ADDENDUM NO. 2

ADA PARKING LOT IMPROVEMENTS PROJECT

SPEC NO. 2026.8518-21

October 7, 2025

See illustration snips from **Sheet 3 of the Bob Kildee Park Pavement, Grading and, Striping Plan** on Pg. 3 of this Addendum. Use Bid Alt Schedule form on page 4 of this Addendum for proposal submittal.

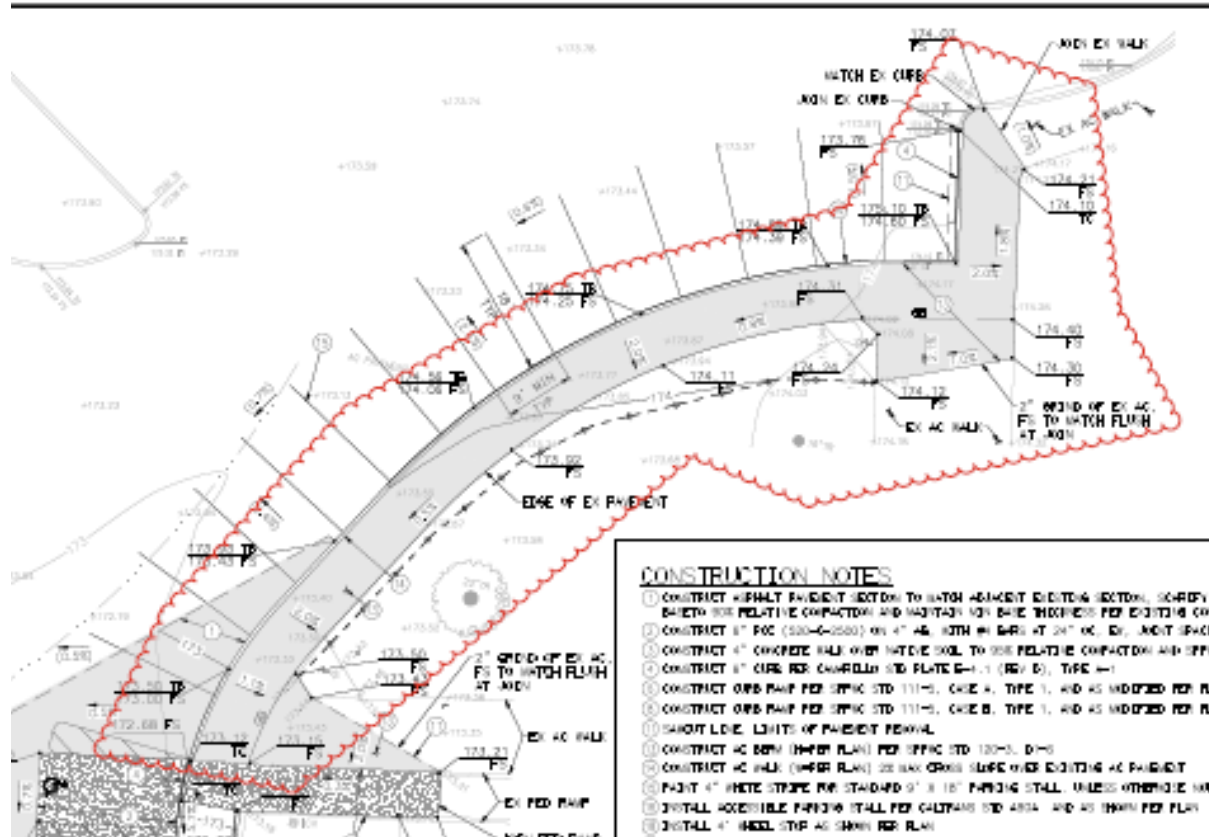
This addendum serves to incorporate an **Add Alternative Bid** for a concrete curb and walkway in lieu of AC berm and walkway. Include any associated costs for additional demolition work necessary for this alternate bid.

The following identifies the area and scope for the Add Alternative Bid (See highlighted construction notes and call-outs):
